♦ ♦ ♦ ♦ **ADDENDUM TO BID** ♦ ♦ ♦ ♦

PRE-ENGINEERED METAL BUILDING

Bid Title: PRE-ENGINEERED METAL BUILDING
Bid No.: 15-5300.PRE-ENGINEERED METAL BUILDING
Addendum No.: 1
Issued: November 21, 2014

ADDENDUM TO: Pre-Engineered Metal Building
Bid No. 15-5300.PRE-ENGINEERED METAL BUILDING (Lube Center)
2:00 p.m., December 2, 2014

WATER DISTRIBUTION PLAN

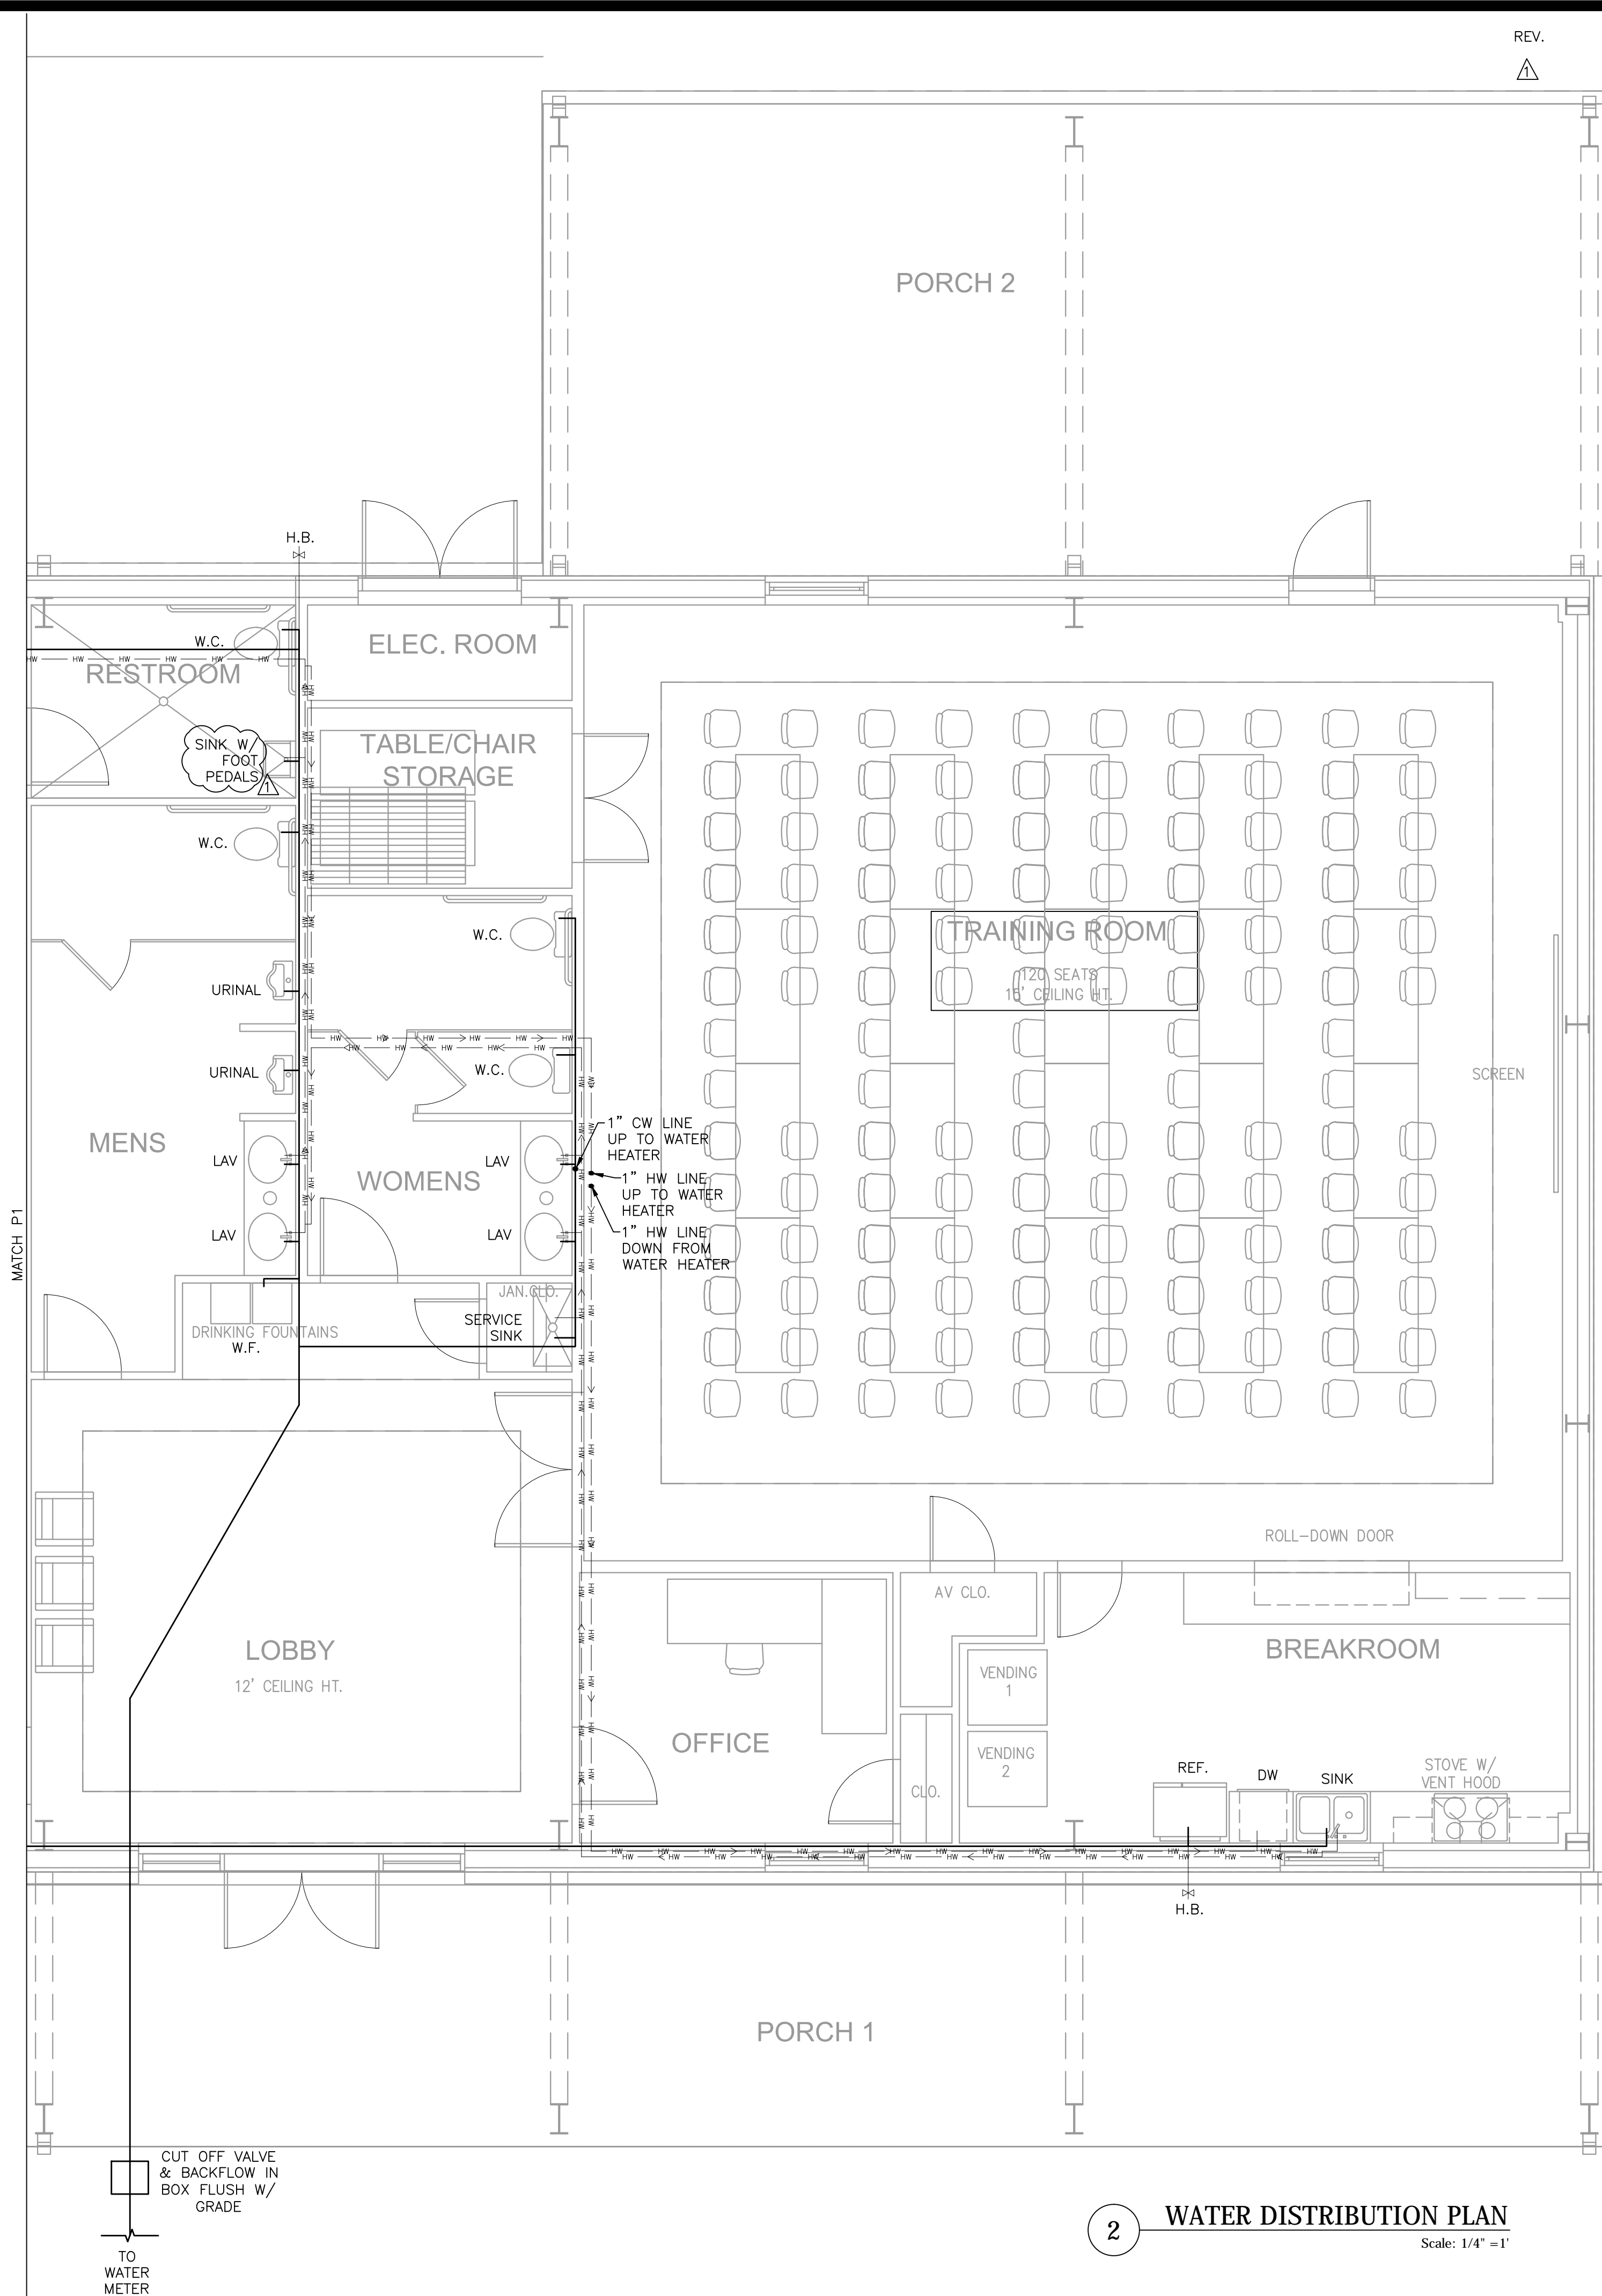
52. *Question:* Which sinks are supposed to be operated by foot pedals?

REV.	DESCRIPTION
1.	ADDED SINK WITH FOOT PEDALS TO THE RESTROOM.

Response: One sink in the maintenance area and one in the maintenance restroom. Please see attached drawings.

GAS DISTRIBUTION PLAN

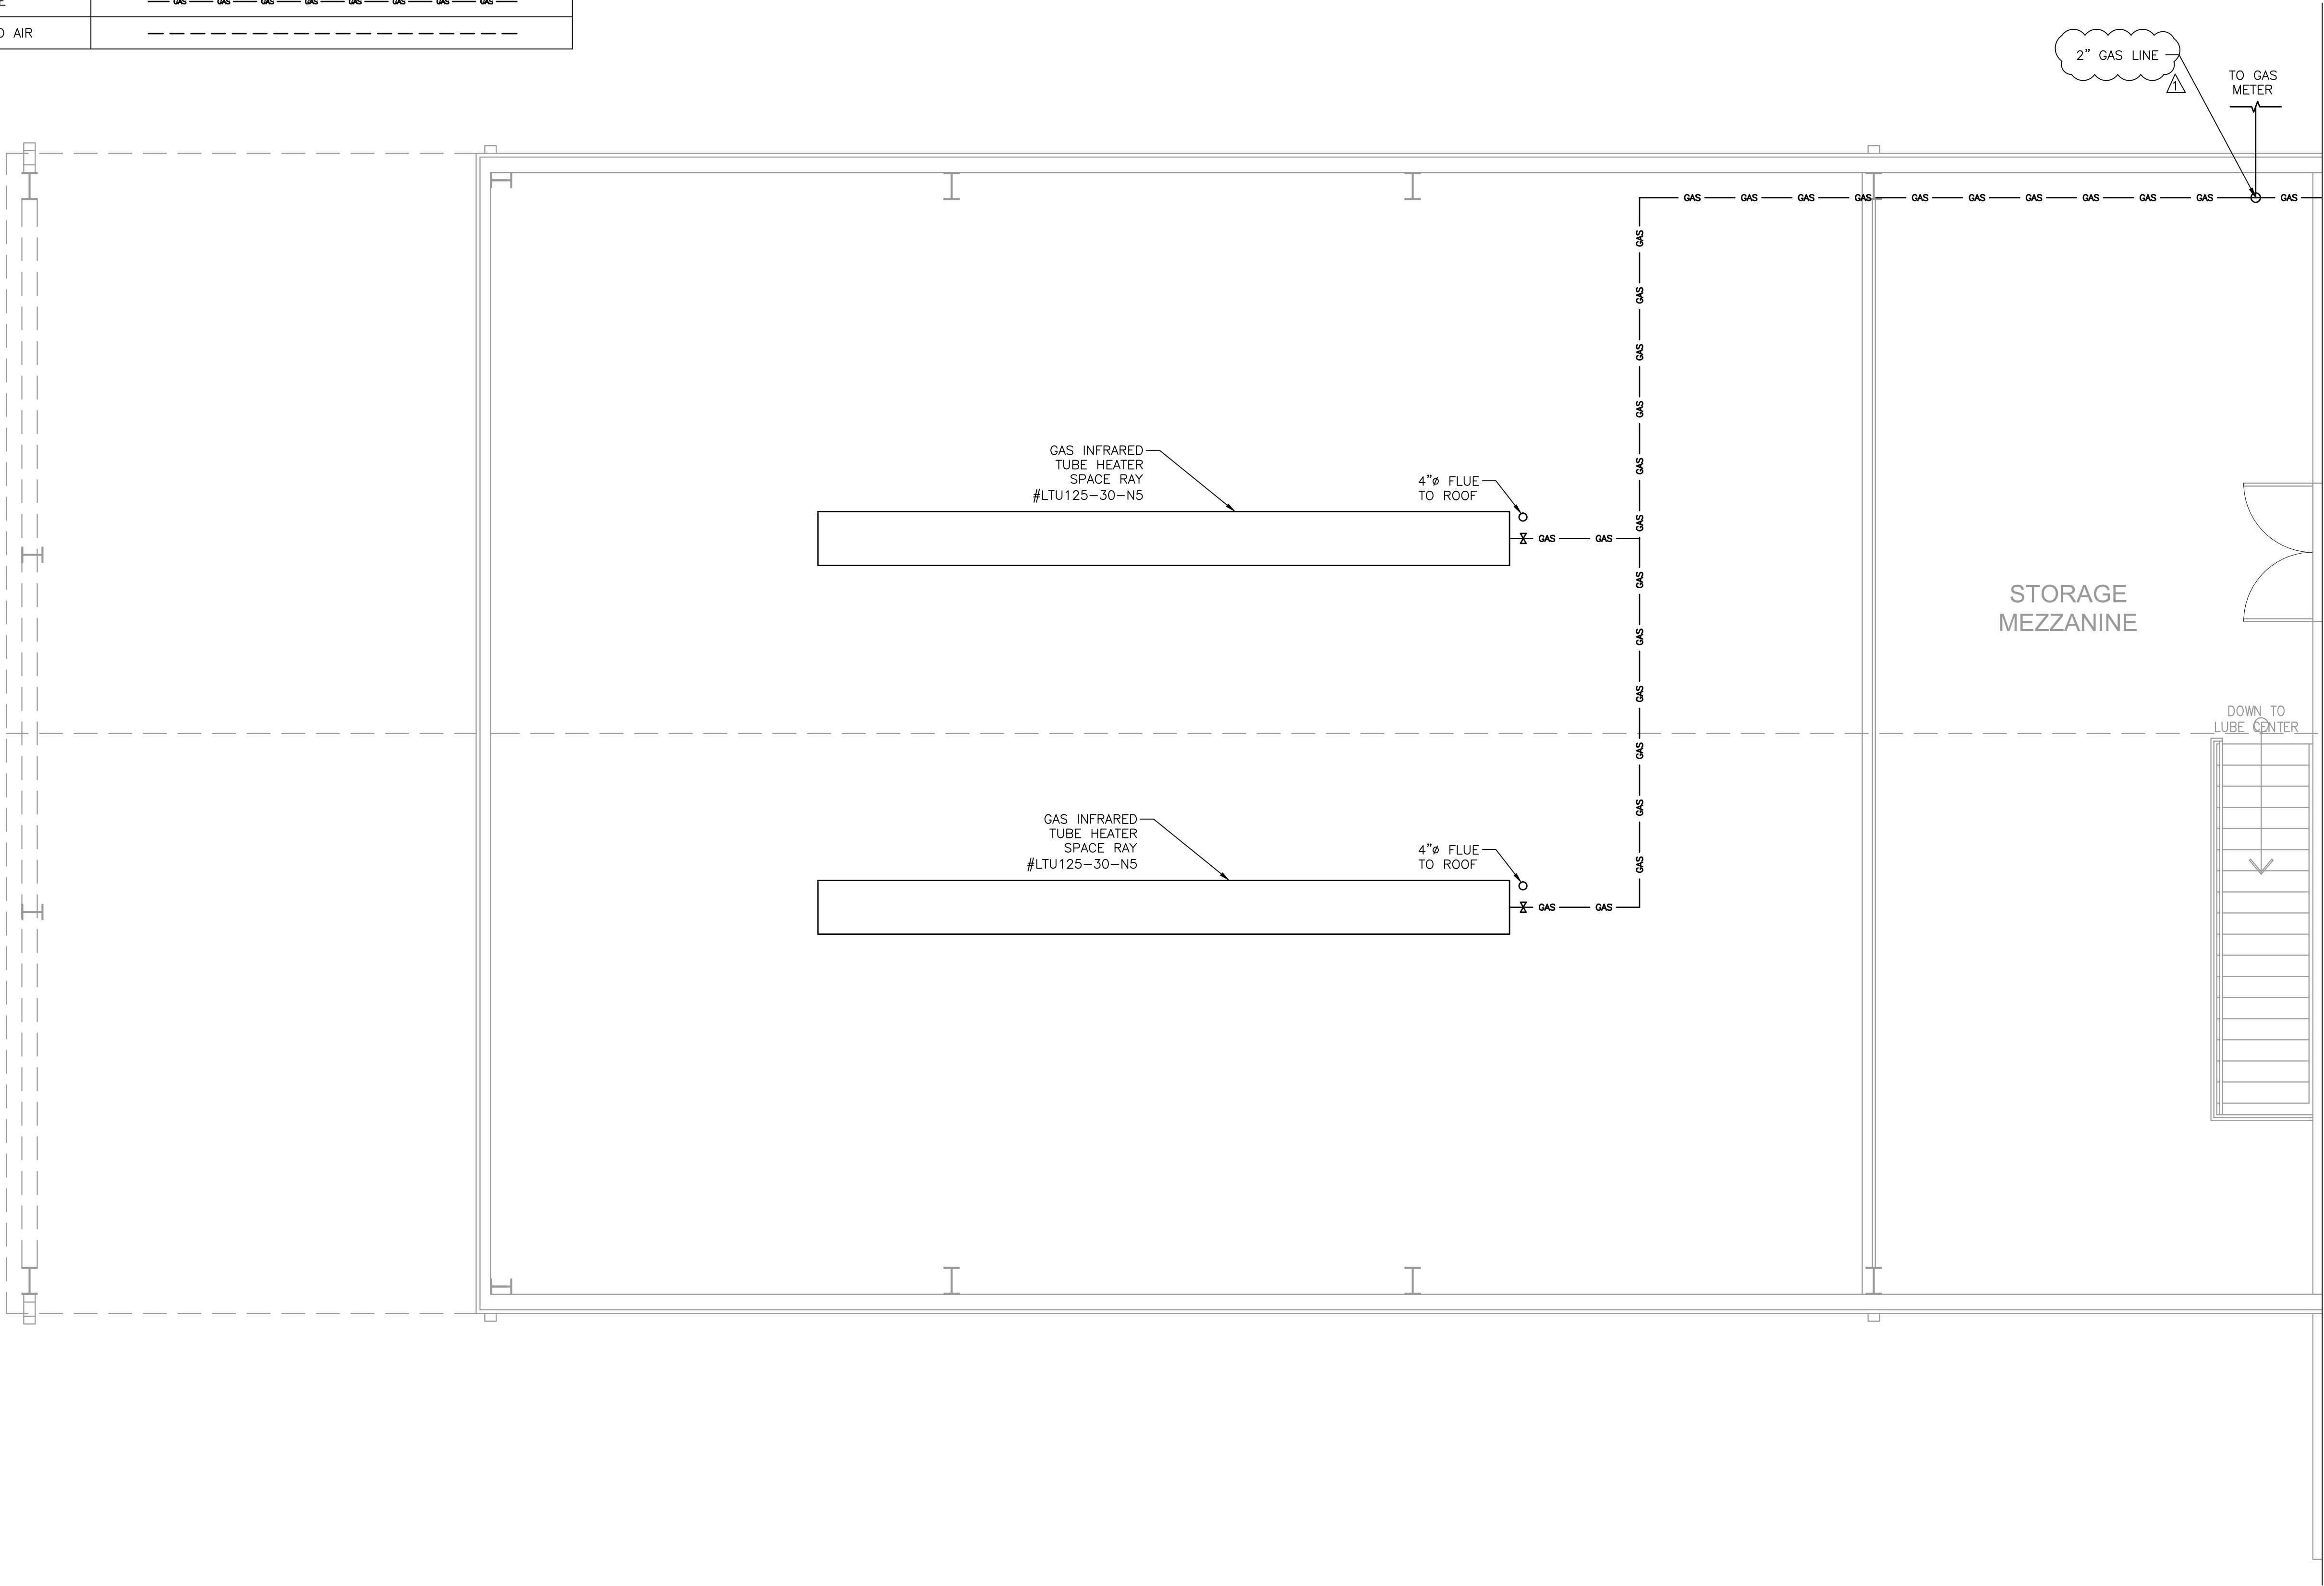
51. *Question:* Can the gas piping system for sized and installed at a lower supply pressure to avoid using gas pressure regulators at each appliance?

Response: Yes. Gas piping was originally sized for supply pressure of 2psi. To avoid regulators, we re-sized the piping for 4oz supply pressure. Please see attached drawings.
